**BRITISH GLIDING ASSOCIATION**

**BGA TECHNICAL COMMITTEE**

**TECHNICAL NEWSHEET TNS 9/10/92**

**PART 1** Airworthiness "AGGRO" Please add to the BGA 1992 Red Pages.

**Subject:** Inspection of drain holes in the elevator  
(including trim tab)

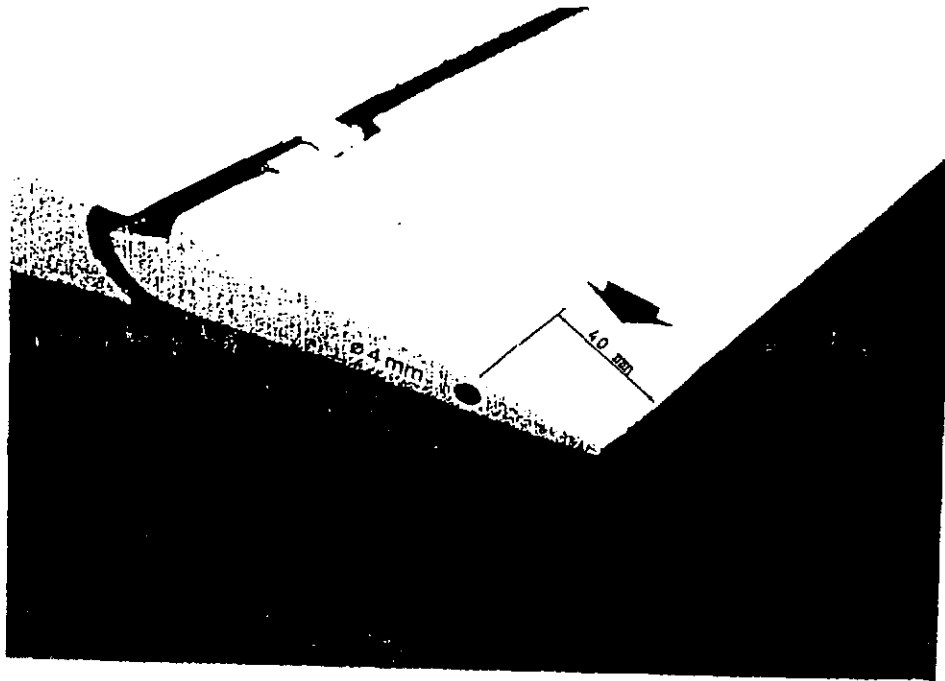
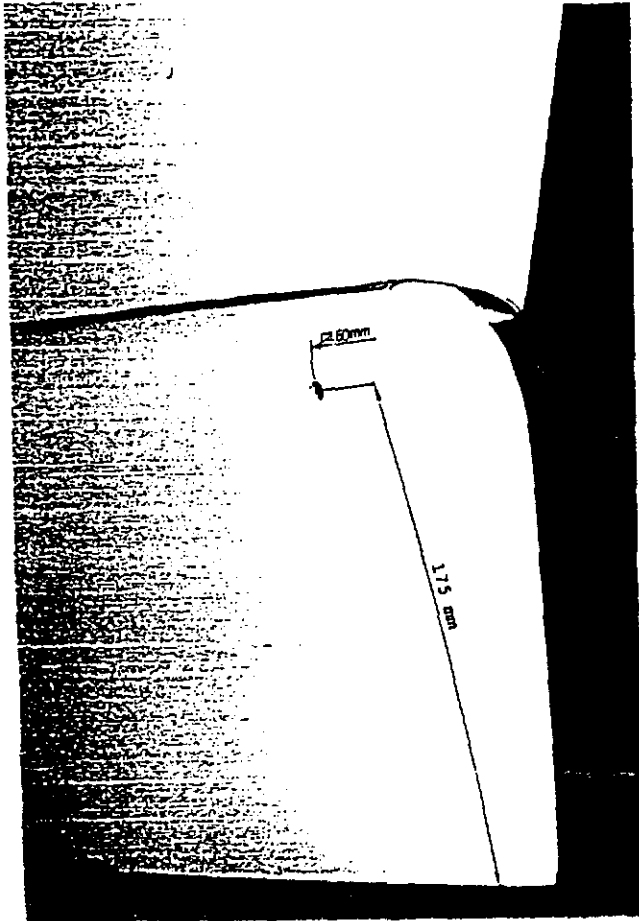
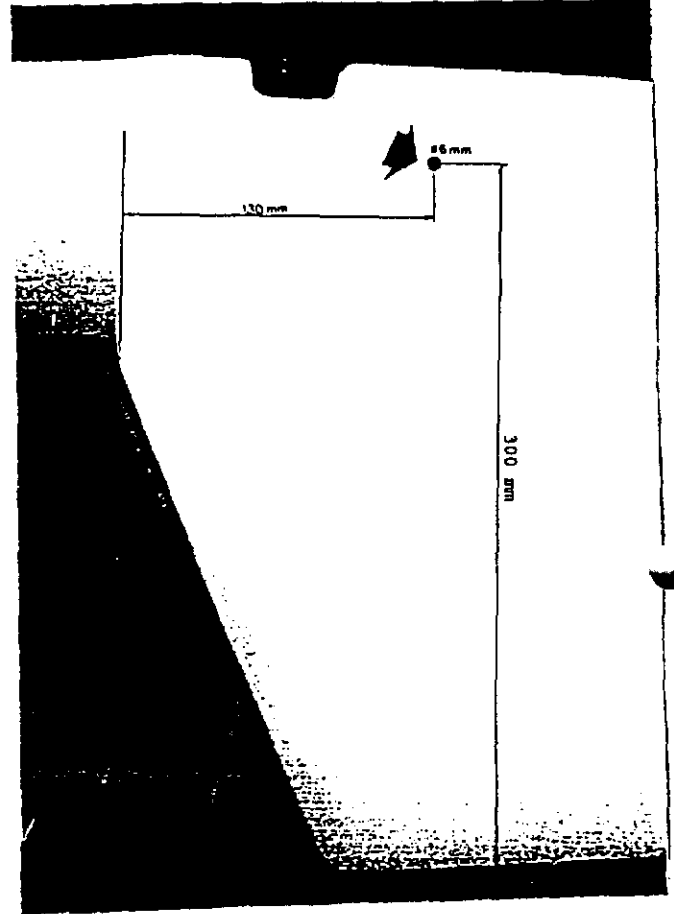
**Procedure:** A sufficient number of drain holes must be provided in the elevator including trim tab. Otherwise the laminate can be damaged by the water penetration, or weight and C.G. problems of the elevator may occur, and cause at the worst flutter tendency.

1. Check for provided and open drain holes at the following positions (quantity: 8):

2. If drain holes are not provided at these positions, drill drain holes of  $\phi$  6 mm or  $\phi$  4 mm according to the figures shown on pages 3 and 4.

6  $\phi$  4 mm

7  $\phi$  4 mm

8  $\phi$  4 mm

1,4  $\phi$  6 mm

2,3  $\phi$  6 mm

5  $\phi$  6 mm

## 7. BRAKE DISCS

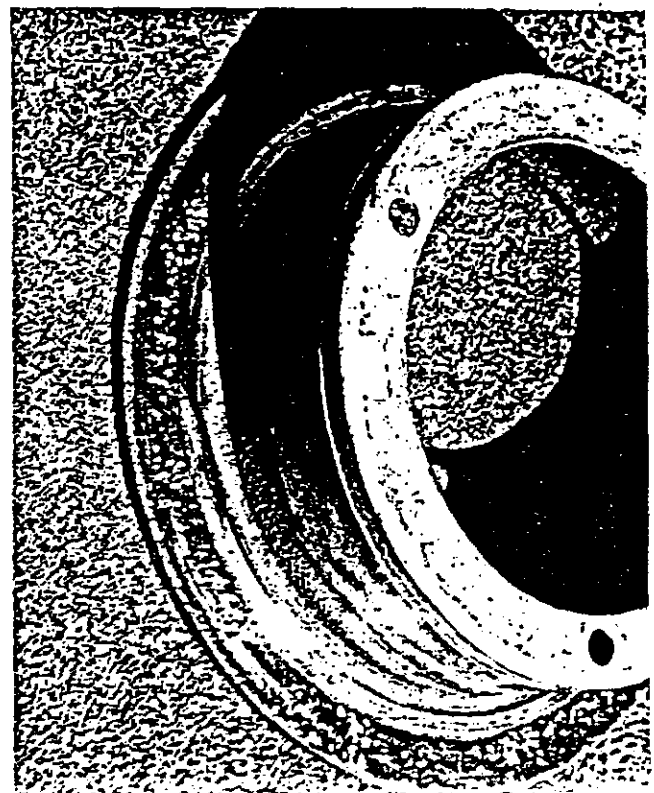
inspection of the brake disc on the left-hand side showed that the metal had corroded to such an extent that, at the junction of the hub with the disc, a sharp object, a car key, could be pushed through to make a series of holes. The failed brake disc is shown in the attached photograph.

The aircraft had been taken to a maintenance organisation in the Northwest of England for its C of A inspection. The brake discs were removed and found to be extremely badly rusted and heavily pitted. In addition, the brake pads had worn through the lining material and the rivets were contacting the disc surface.

Corroded brake discs are clearly a continuing problem and requires vigilance by pilots on pre-flight inspections and engineers on scheduled maintenance checks.

SUBJECT : AIRBRAKES CONTROL CHECKING IN THE FUSELAGE

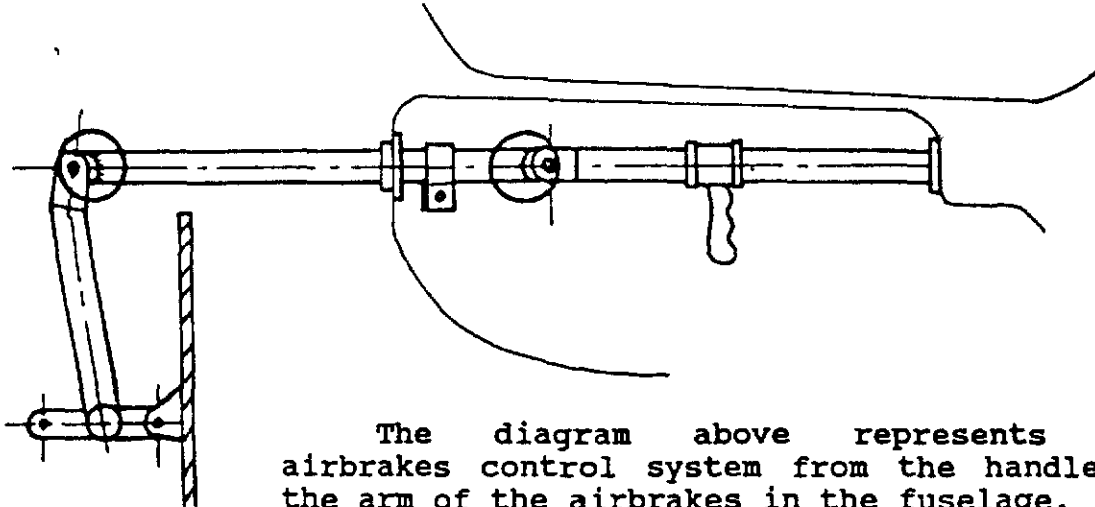
The diagram above represents the airbrakes control system from the handle to the arm of the airbrakes in the fuselage. All weld parts and especially all above encircled parts should be very carefully eye-checked. If necessary and after cleaning, use a mirror or a lamp to check if there is any crack starts.

- To inspect each glider as it is described above during the next small maintenance inspection.

- To contact SN CENTRAIR in case of cracks.

SF. 27.A      See text overleaf

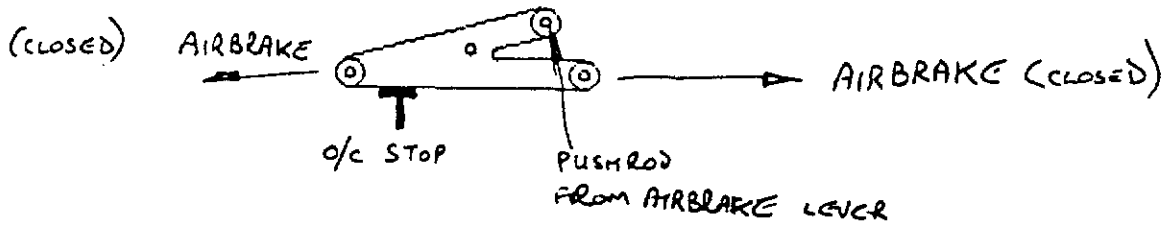
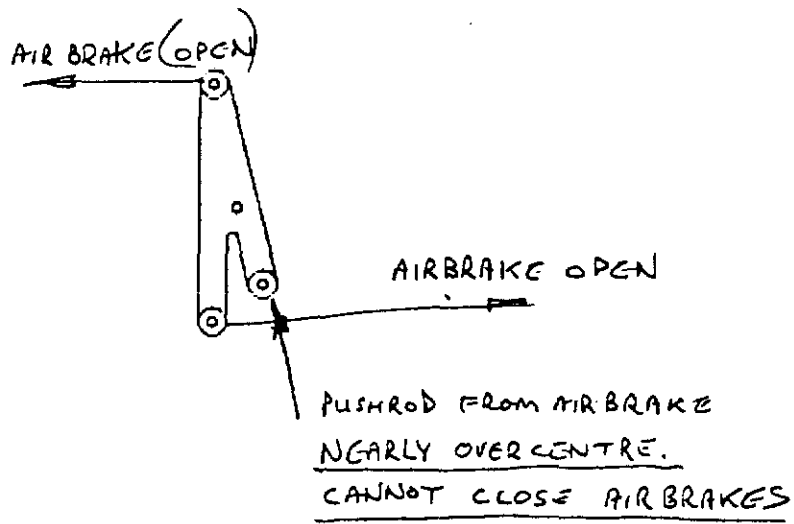
At our recent Annual Shutdown we stripped and cleaned all the control linkage bearings and on replacing them found that the starboard airbrake paddle was not flush with the wing surface when closed so the rod was adjusted to achieve the desired condition. The aircraft functioned satisfactorily until the incident. Upon examination after the incident it was found that the brakes did not go overcentre and lock properly. This was at the end of the recent very hot weather and it is thought that something must have expanded/contracted such that the starboard brake paddle whilst being flush was preventing the overcentre mechanism from functioning correctly (the mechanism is on the port wing). When re-adjusted the mechanism worked correctly.

What wasn't realised was that adjustment of the wheelbrake affects the amount of deployment of the airbrake i.e. the wheelbrake is the stop for full airbrake.

When the airbrakes are deployed normally, the amount of movement is restricted by one's elbow catching on the side of the cockpit but when they deployed on their own the lever went further than was formerly possible and the linkage from the airbrake lever to the operating quadrant on the wing went nearly over centre which had the effect of not being able to close the airbrakes.

We are now fitting a stop on the airbrake control to prevent this happening again.

SUBJECT: Attachement of the elevator (T-fitting)

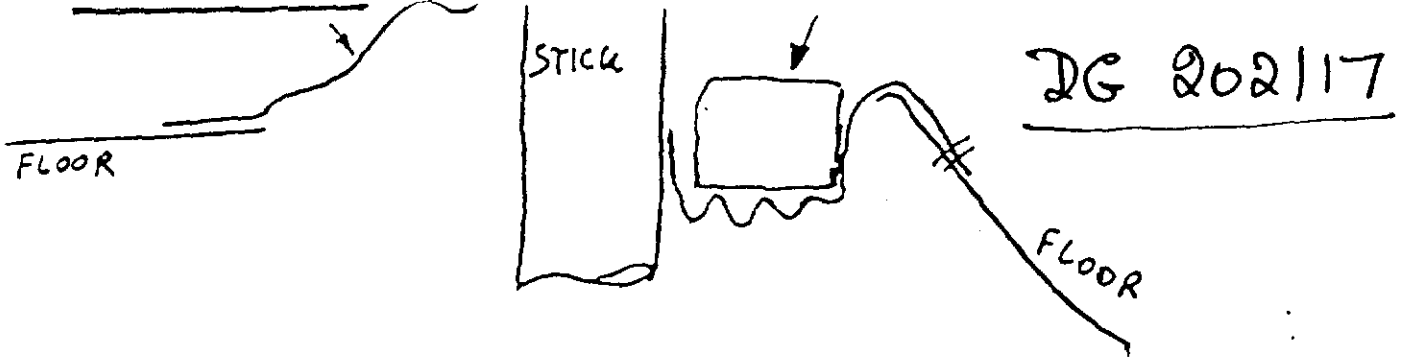
On some sailplanes fine cracks in the welded  
joint of the pins on the elevator attachement  
T-fitting were observed.

Put a sleeve tube with 10 mm inner diameter  
onto the pins, apply force in span direction  
and at the same time inspect the welded  
joint of the pins for fine cracks using an  
at least five-fold magnifying lens.

2. If fine cracks in the welded joint should be  
observed, rework the welding utilizing elec-  
tric arc welding.

1. See above text
2. See above text
3. If it should occur again ask the  
manufacturer.

POSSIBLE ELEVATOR JAM BY MICROPHONE

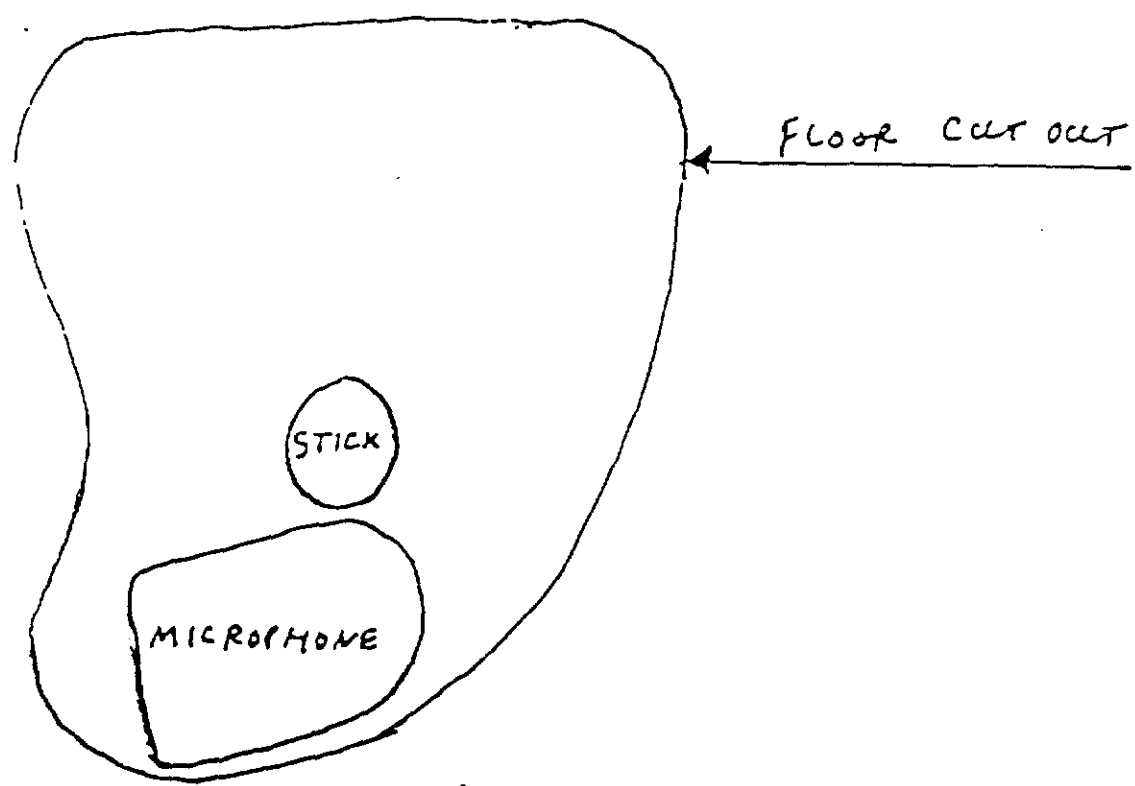
- 1.4. Centrair Type 101 all Variants. S.B. 101-16-Checking of the Airbrake Control System. (herewith).
- 1.5. DG 200-17 - Possible Elevator Jam By Microphone causes serious accident at Cotswold G.C. Sketch herewith explains the possibility.
